REVISION #4

REVISION	DATE	COMMENTS
4	02/03/26	CONTRACTOR REVISIONS

PROJECT:
CORNISH LIBRARY & COMMUNITY CENTER
226 NH-120
CORNISH FLAT, NH 03746

ISSUED:
CONSTRUCTION DOCUMENTS

SKS-001
DATE: 10/21/25
EV PROJECT #: 23264

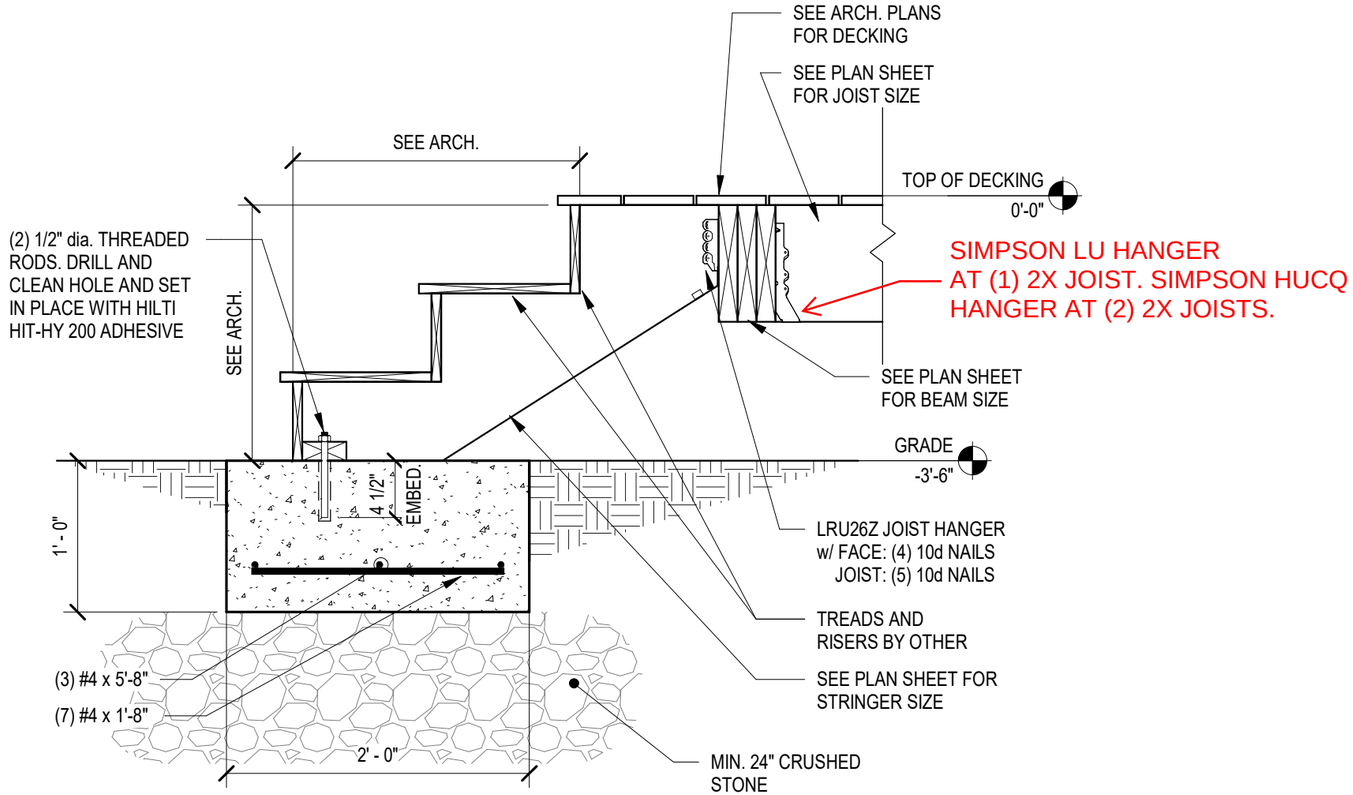
NOTES:
1. EV COMMENTS IN RED. REF. RFI #2, SHEETS S301, AND A401.
2. LEDGER ATTACHMENT TO EXISTING STRUCTURE SHALL BE (3) FASTENMASTER LEDGERLOK SCREWS @ 16" o.c. HORIZONGAL SPACING.
3. POST BASES - SEE DETAIL 1/S301. POST CAPS - SIMPSON BCS CAPS.

C2 TYPICAL EXTERIOR STAIR RAILING SECTION
Scale: 3" = 1'-0"

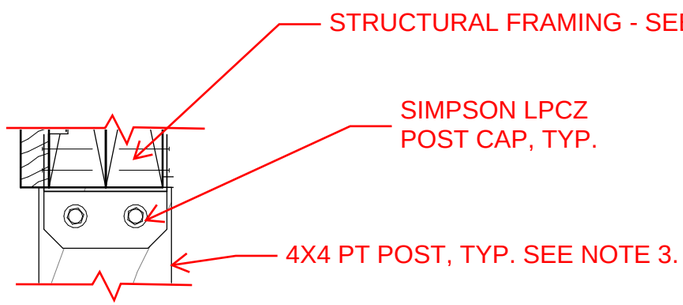
COMMENTS:
1. EV COMMENTS IN RED.
2. REF. DETAIL C2/A401.
3. PROVIDE ABU POST BASES, SIMILAR TO GRIDS G.9, 1 AND 2. PROVIDE 5/8" DIA. THREADED ROD ANCHORS FOR ATTACHMENT TO POST BASES TO CONCRETE, EMBEDDED 2 1/2" MIN. WITH RED HEAD A7+ EPOXY, TYP.

7 TYPICAL THICKENED SLAB AT INTERIOR SPREAD FOOTING
1/2" = 1'-0"

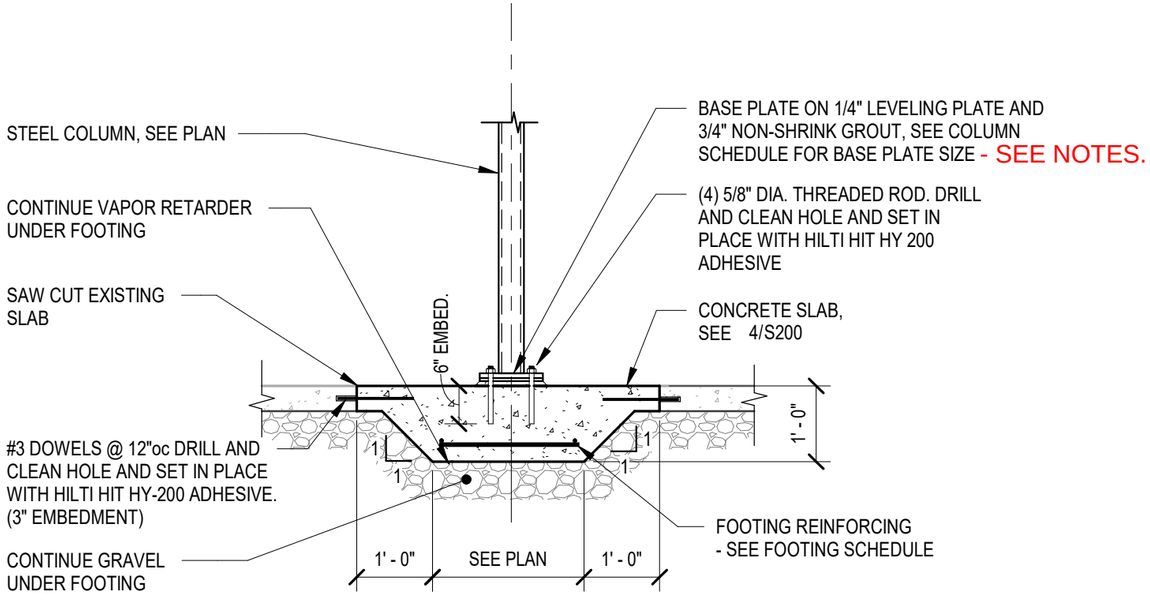
NOTES:
1. EV COMMENTS IN RED.
2. REF. DETAIL 7/S200.
3. REF. RFI #016. WE DO NOT TAKE EXCEPTION TO THE BASE PLATE POSITION RELATIVE TO THE COLUMN CENTERLINE AS PER THIS RFI.

SKS-008
DATE: 01/06/26
EV PROJECT #: 23264

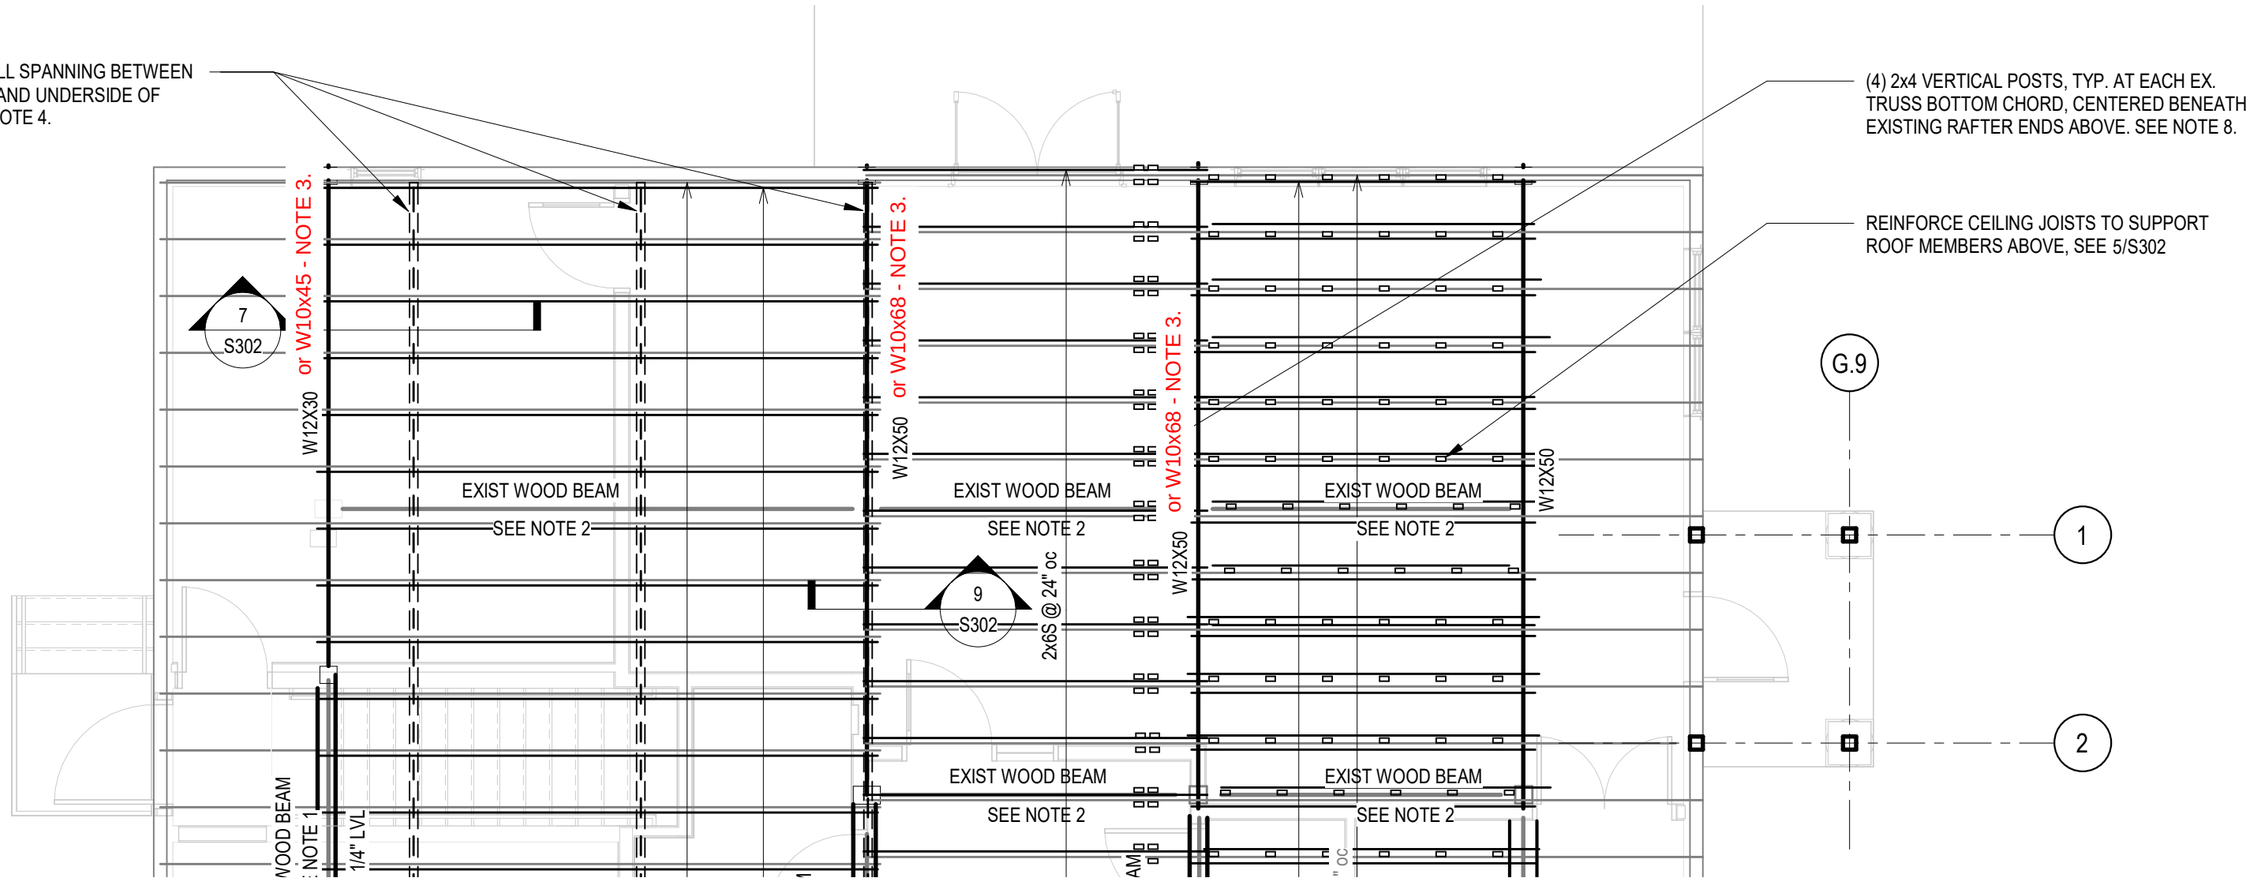
NOTES:
1. REF. RFI FROM T-N REC'D 2026/1/5.
2. REF. SHEET S102A.
3. CONTRACTOR OPTION TO REVUEW W10 BEAM OPTION WITH THE ARCHITECT AND PROVIDE W10 BEAMS LIEU OF ORIGINALLY SPECIFIED W12 BEAMS IF THE ARCHITECT DOES NOT TAKE EXCEPTION.

SKS-009
DATE: 01/08/26
EV PROJECT #: 23264

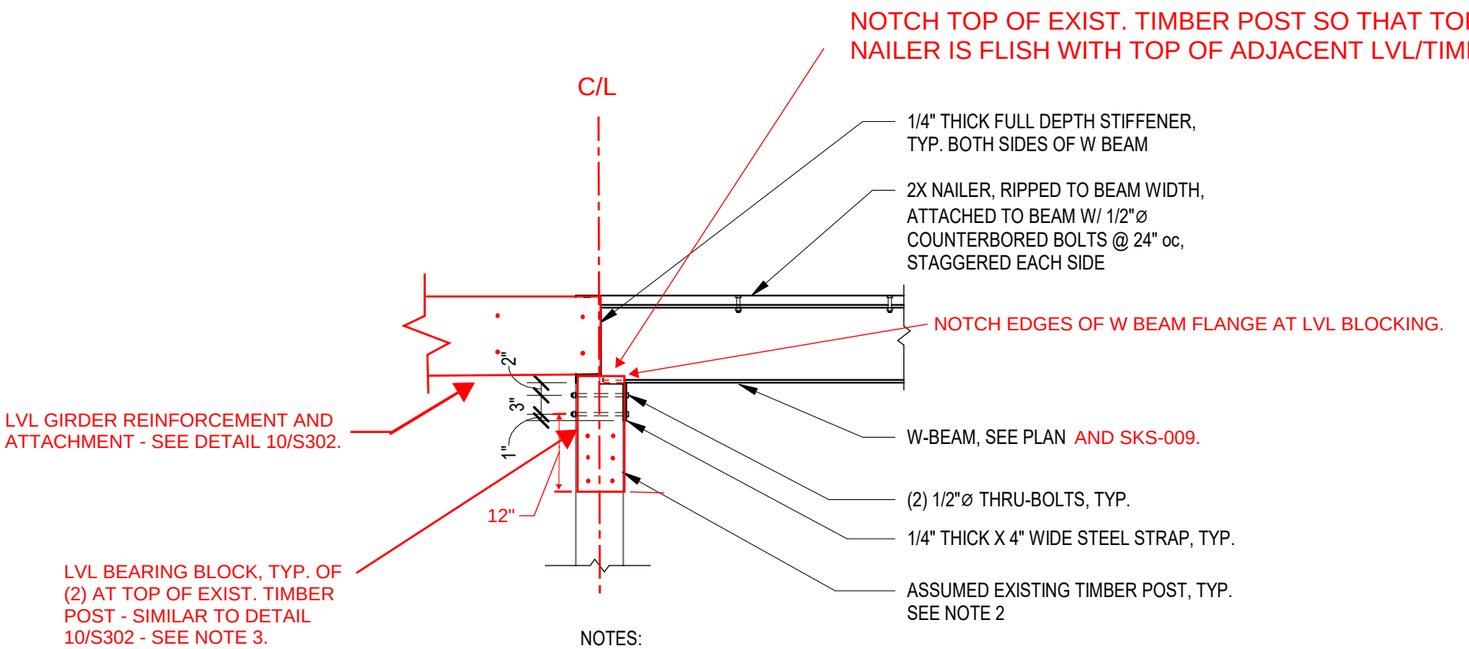
1. PROVIDE 1/4" FILLET WELDS BOTH SIDES OF ALL PLATES, ALL EDGES IN CONTACT W/BEAM AND OTHER PLATES.
2. PROVIDE BUILT-UP 2X POST BENEATH W BEAM END AT LOCATIONS WHERE THERE IS NOT AN EXISTING POST, SIMILAR TO DETAIL 10/S300
3. THIS DETAIL IS SIMILAR TO 10/S302, MODIFIED AS FOLLOWS: LVL BLOCKING LENGTH EXTENSION POSITIONING OF SDS SCREWS FOR BLOCKING ATTACHMENT TO PRECLUDE INTERFERENCE WITH STEEL BEAM ATTACHMENT THROUGH-BOLTS AND SDS SCREWS.

PARTIAL FRAMING PLAN - REF. SHEET S102a
AND RFI FROM CONTRACTOR REC'D 1/14/26 — 1

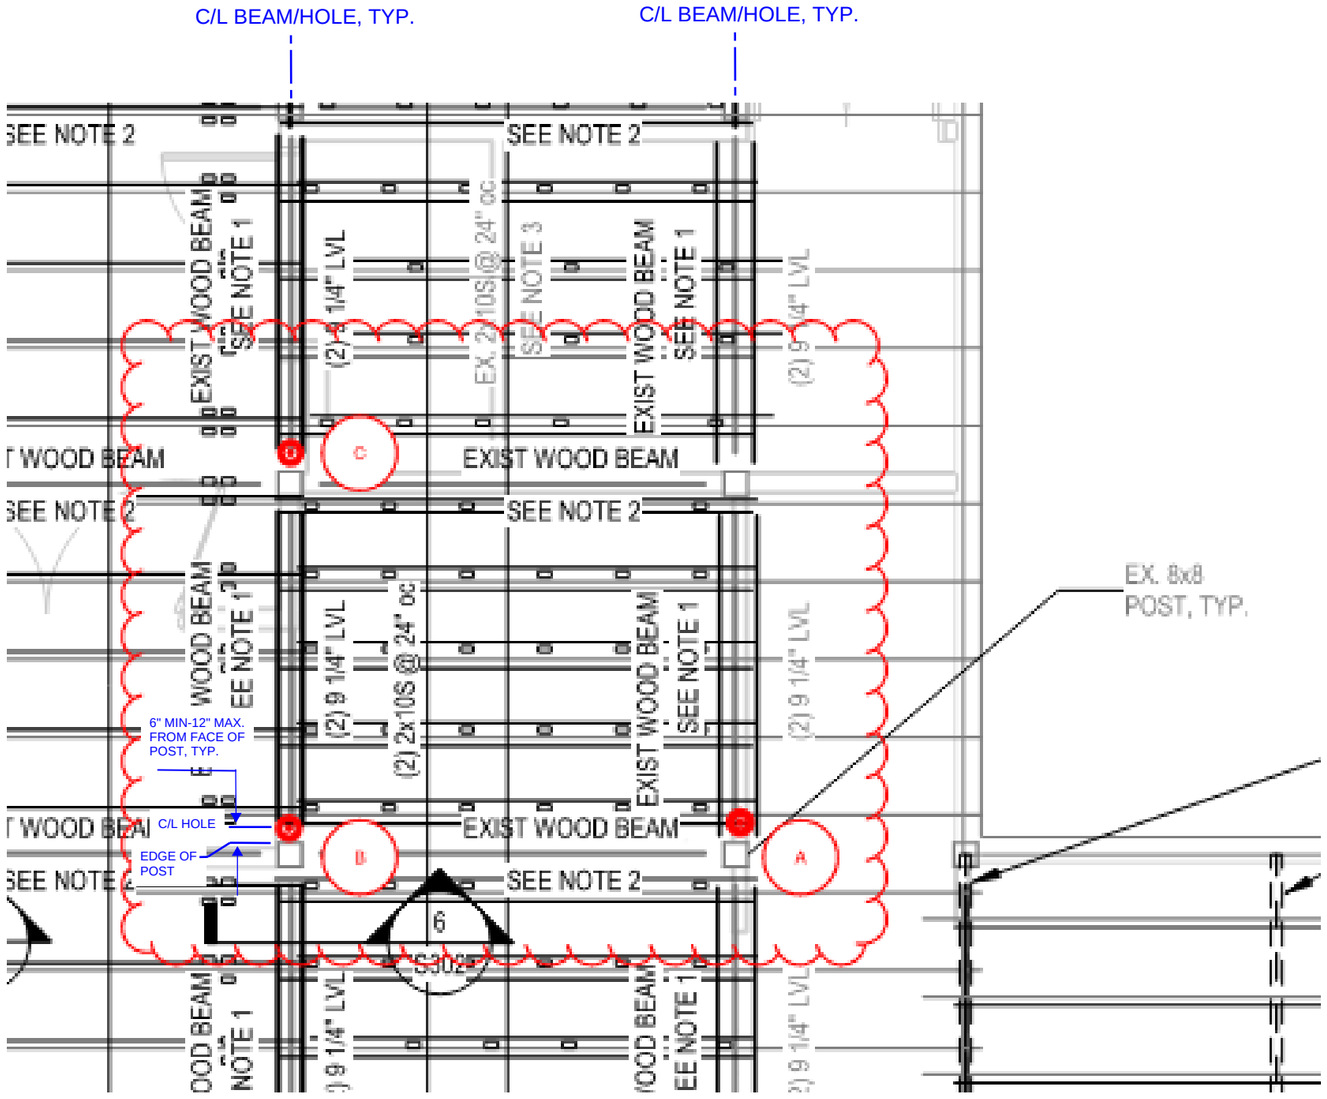
NOTES:
1. EV COMMENTS IN BLUE. T-N 1/14/26 RFI MARKUPS IN RED.
2. THE CONTRACTOR CAN PROVIDE (1) VERTICAL 3/4" DIA. HOLD IN EACH OF LOCATIONS A, B. AND C, ABOVE. THE HOLES SHALL BE CENTERED ON THE BEAM WIDTH AND PLACED IN A RANGE OF HORIZONTAL DIMENSIONS BETWEEN 6" -12" FROM THE NEAREST EDGE OF WOOD POST SUPPORT BELOW.
